MILITARY SPECIFICATION
TEST SET, TS-3389/URN, OMEGA RECEIVING SET

This amendment forms a part of Military Specification MIL-T-28820(EC), dated 19 May 1975, and is approved for use by the Naval Electronic Systems Command and is available for use by all Departments and Agencies of the Department of Defense.

FIGURE 1. Single-phase test diagram for leakage current measurement.

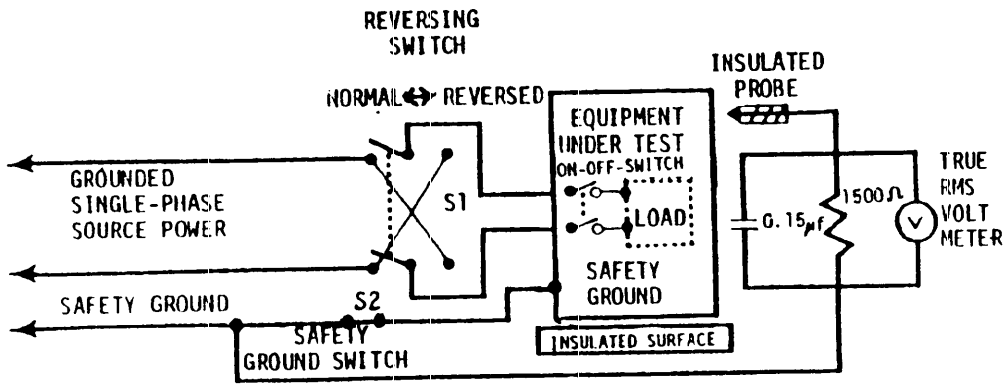
After "4.6.5": Add the following new paragraphs and FIGURES:

4.6.6.1 Equipment test connection. After power removal, each equipment directly connected to an external power source and units deriving power from the equipment shall be placed on an insulated surface. All safety ground conductors between the equipment and units deriving power from the equipment shall be intact. The safety ground conductor between the equipment and the source power shall be opened during the test. OBSERVE WARNING STATEMENT. The equipment shall be connected as shown in FIGURE 1 if it is connected to single-phase source power.

4.6.6.2 Measurement. Leakage current shall be measured on equipment in its normal operating configuration. Equipment controls in each operating mode shall be such that maximum power will be utilized during leakage current measurements. The leakage current shall be determined by the voltage-drop method. A true root-mean-square voltmeter shall be used. The voltage measured across the 1500-ohm resistor, when equal to 7.5 V, represents 5 milliamperes of leakage current. The overall measurement error shall not exceed five percent. The probe shall be used on all external conducting parts such as case, connector housings, recessed calibration or adjustment controls, and control shafts with knobs removed. The voltage shall be measured from each part to ground for every combination of switch positions available in the test diagram. The open safety ground conductor shall be reconnected immediately after the test is completed.".

FIGURE 2. Random vibration curve.

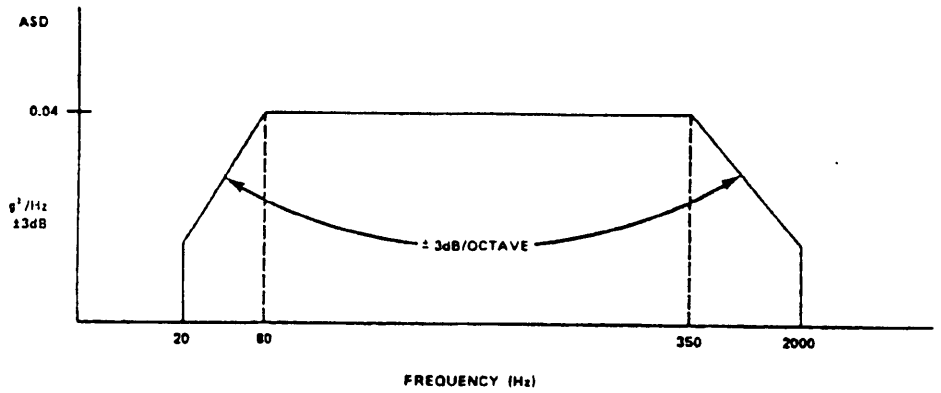
4.6.8.1 Vibration. The vibration shall be random, or subject to procuring activity approval, pseudo-random or complex waveform vibration, for an accumulated time of 10 minutes in the axis deemed most susceptible to vibration excitation. All items shall be hard-mounted (without shock isolators) and subjected to the vibration conditions of FIGURE 2. The control accelerometer shall be located next to one of the mounting points of the item under vibration. Spectral analysis equipment having a bandwidth no greater than 10 Hz for vibration frequencies up to 500 Hz and 100 Hz for vibration frequencies above 500 Hz shall be used for the control and analysis of the acceleration spectral density. The item shall be energized during vibration and appropriate input signals applied to observe any abnormal conditions of the output functional characteristics. All failures occurring during screening shall be corrected and the vibration resumed.".

FIGURE 3. One cycle of temperature curve (not to scale)."

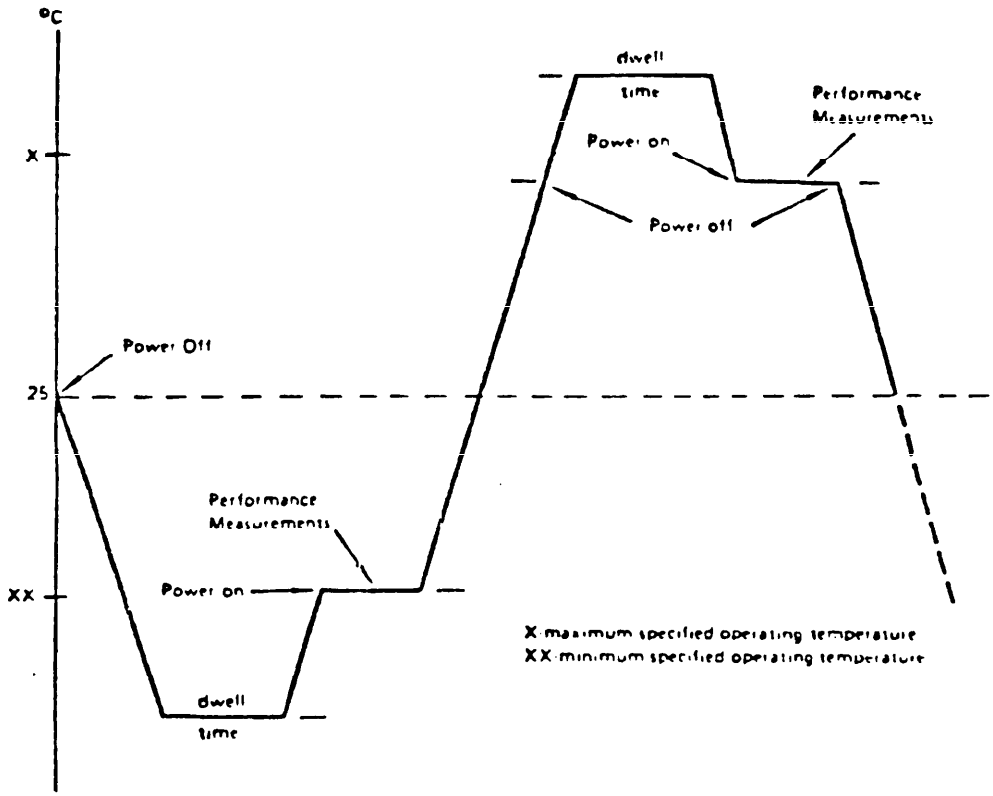
4.6.8.2 Temperature cycling. Each equipment shall be subjected to 10 cycles of the temperature curve, FIGURE 3. The temperature rate of change shall be not less than 5° Celsius per minute. Equipment power shall be turned on and off at the indicated times. The equipment shall be positioned for maximum exposure to the changing temperature. Where performance measurements are called for, a minimal functional operational test shall be performed. The dwell time shall be maintained until the largest electrical or electronic part in the equipment reaches 80 percent of the chamber temperature. When failures occur, the equipment shall be reworked and the cycling continued for a cumulative total of 10 cycles.
